J2023-0002  
PSP2023-0014  
Revision #4  
Received 9/20/2023

**Site Plan Review**

**EAST HAMLIN ROAD STORAGE**

**PRELIMINARY SITE PLAN**  
**1575 E HAMLIN RD**  
 PART OF THE SE 1/4 OF SECTION 24, T3N, R11E  
 ROCHESTER HILLS, OAKLAND COUNTY, MICHIGAN

Drawing Name  
**BUILDING EXTERIOR ELEVATIONS**

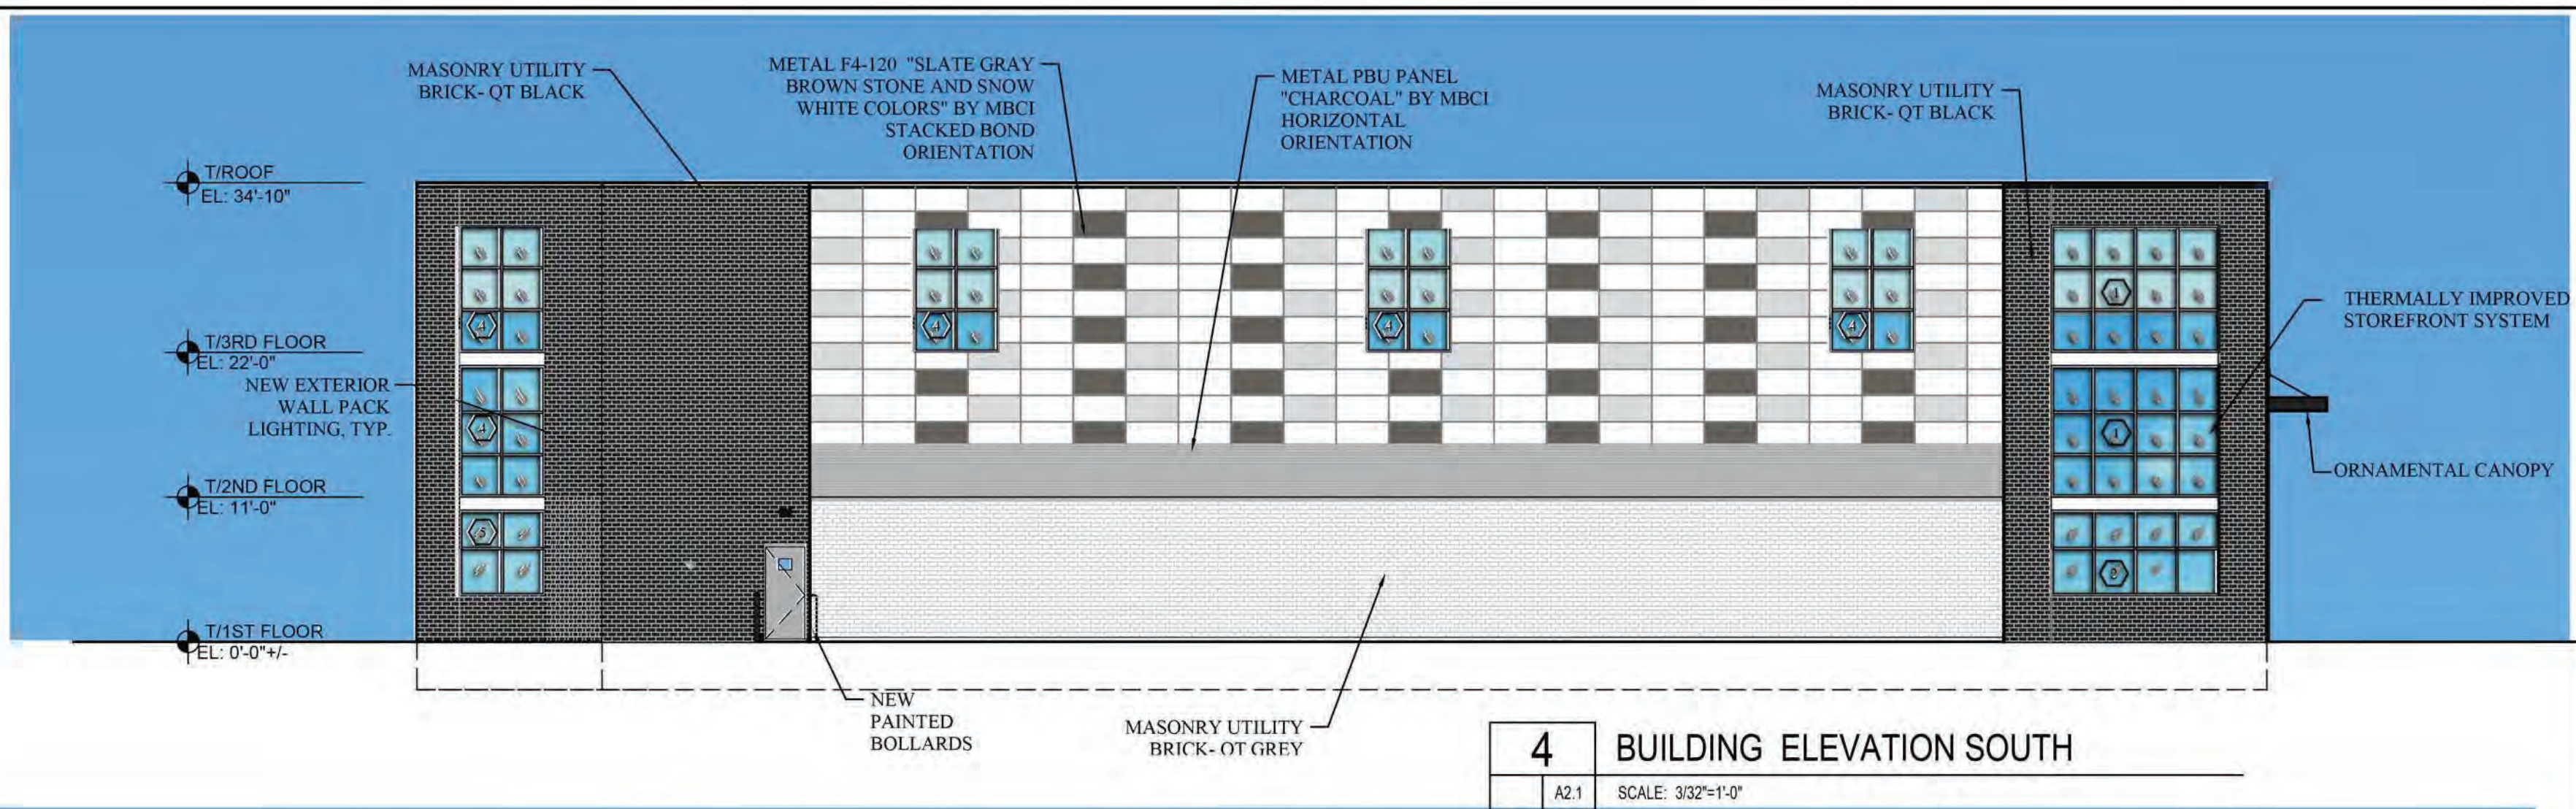
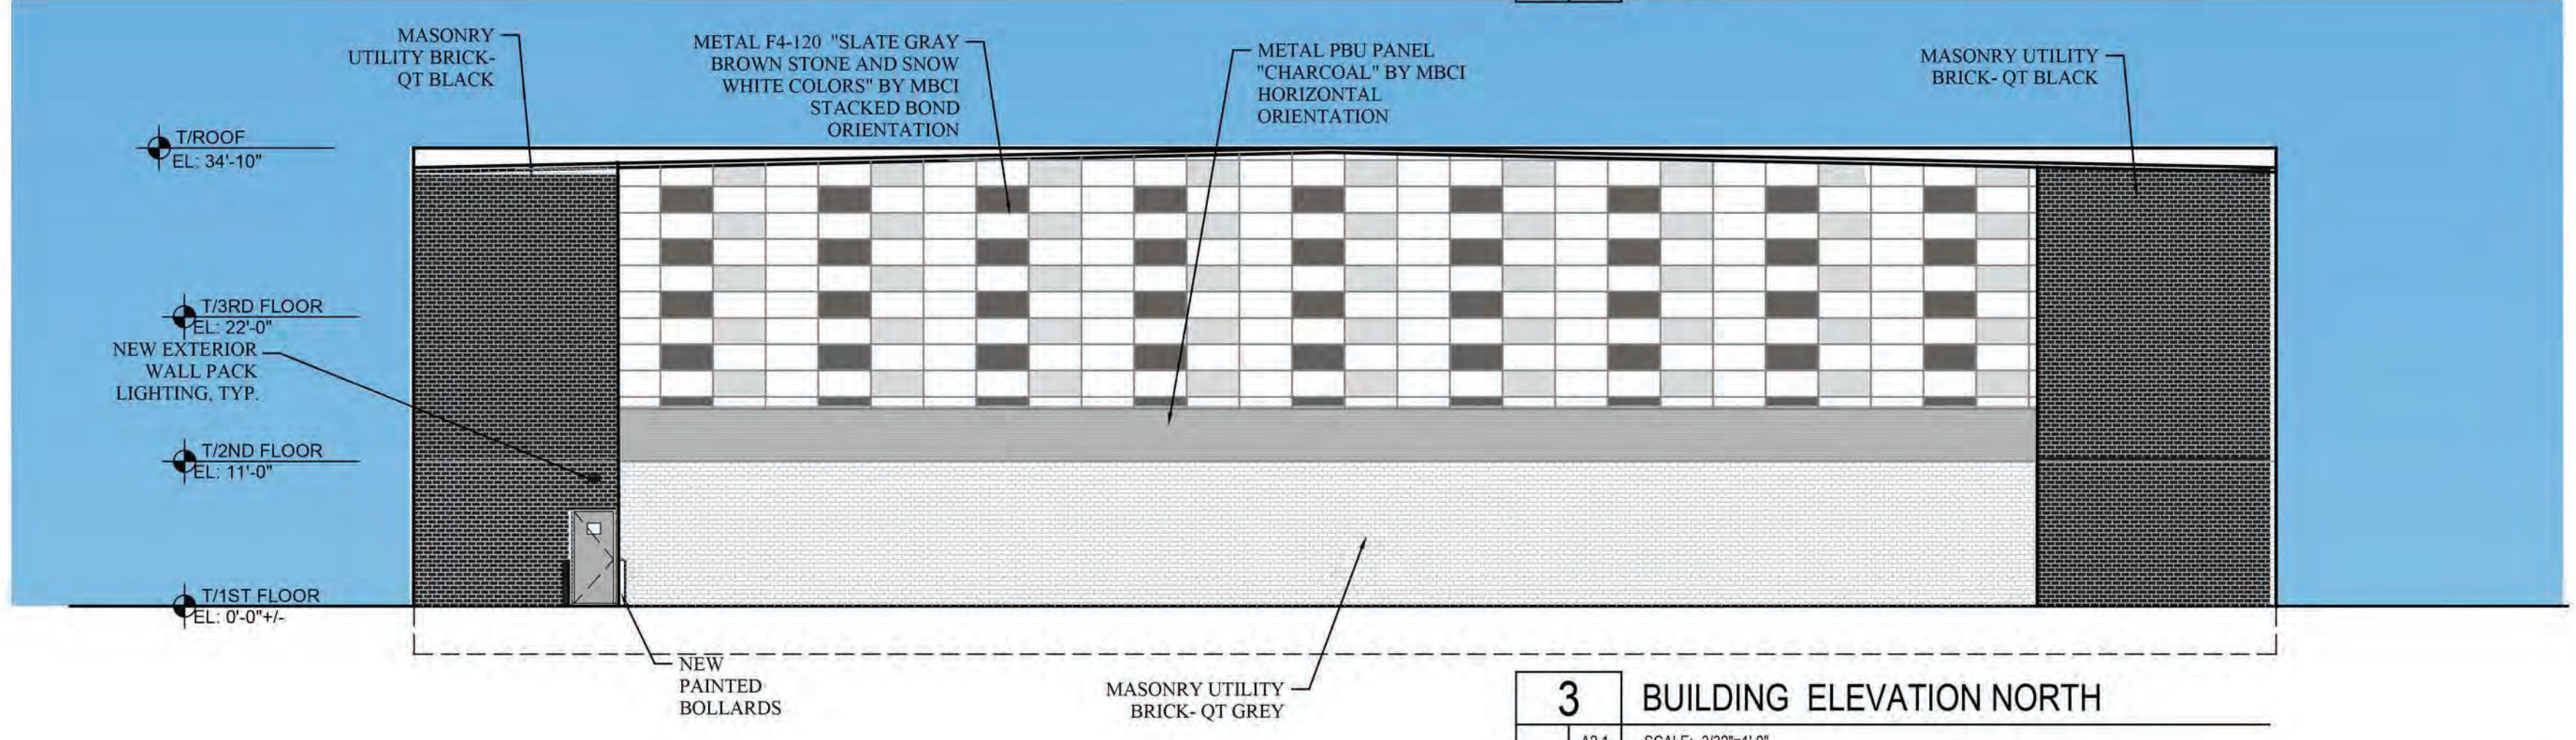
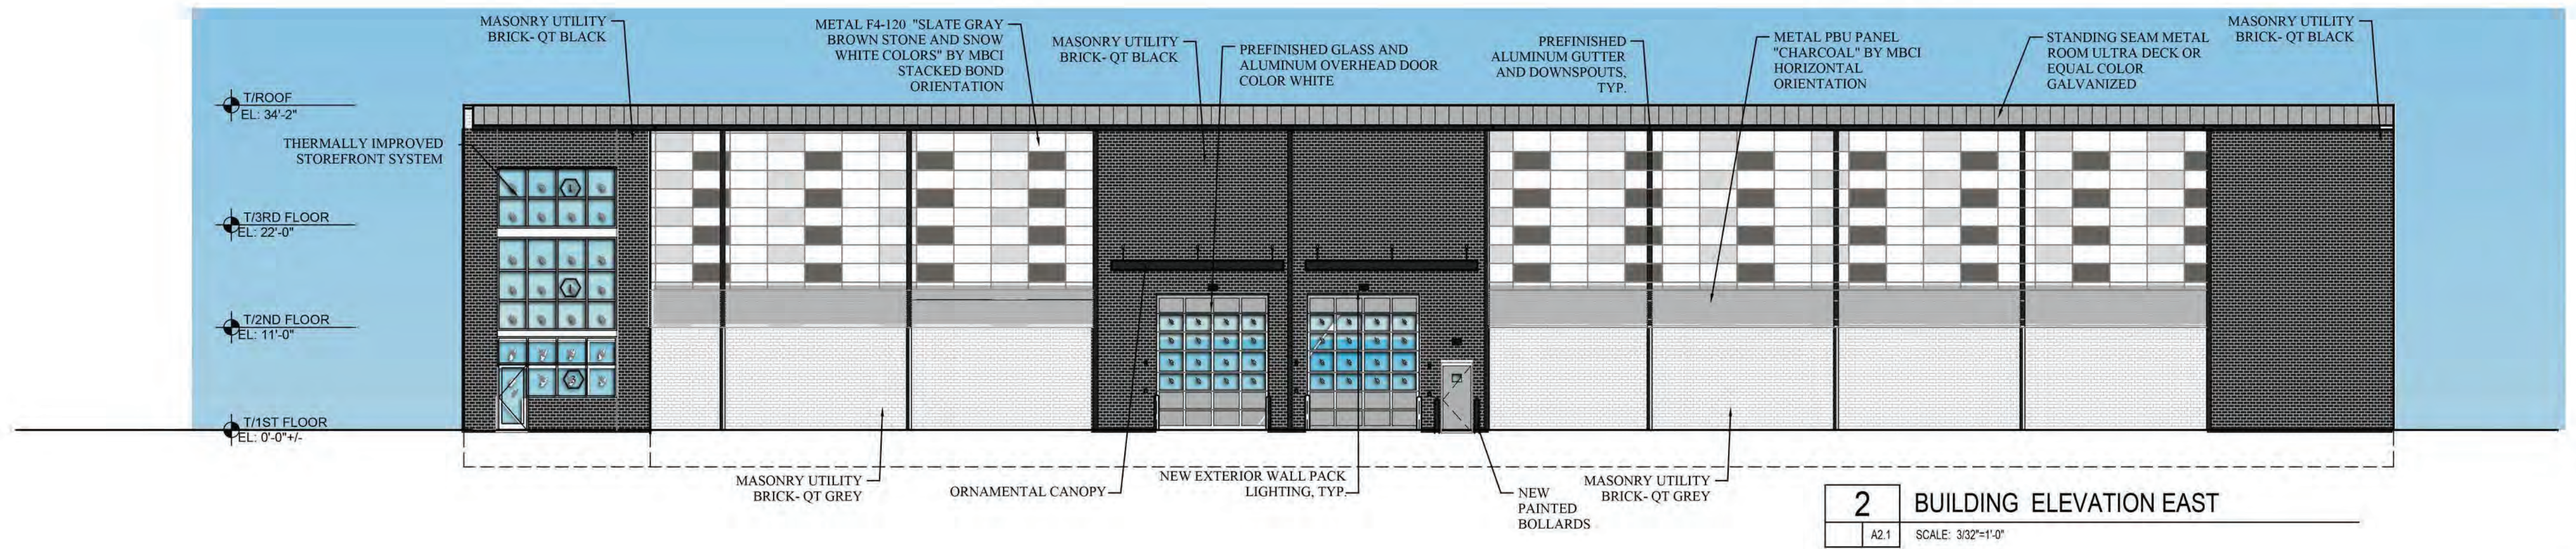
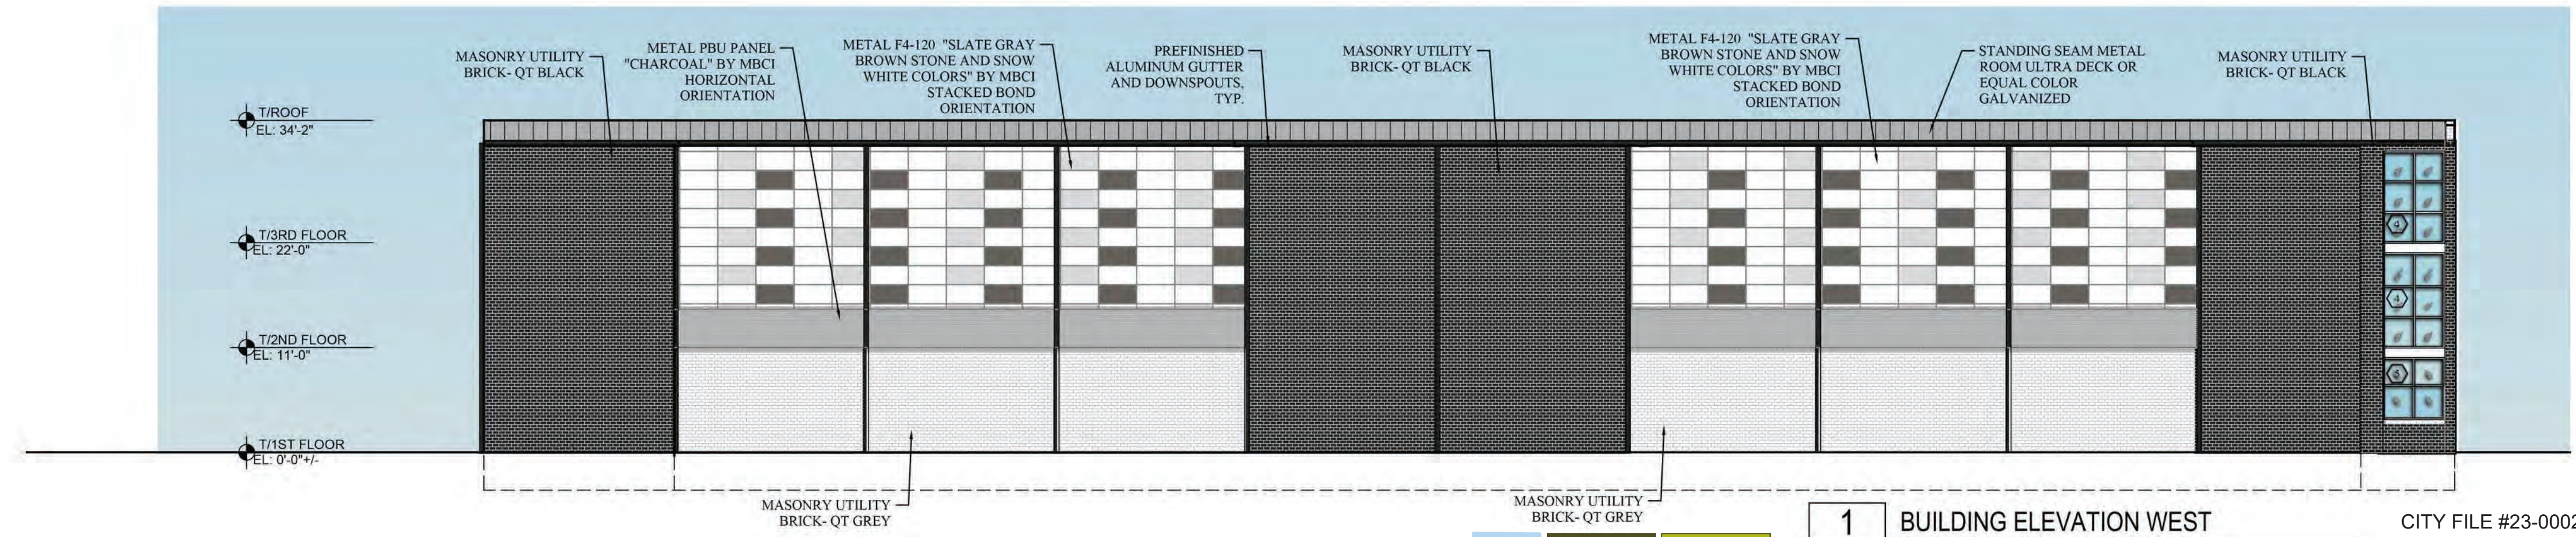
All signs must meet the requirements of the City and be approved under separate permits issued by the Building Department.

Signs are a part of a separate review and permit process.
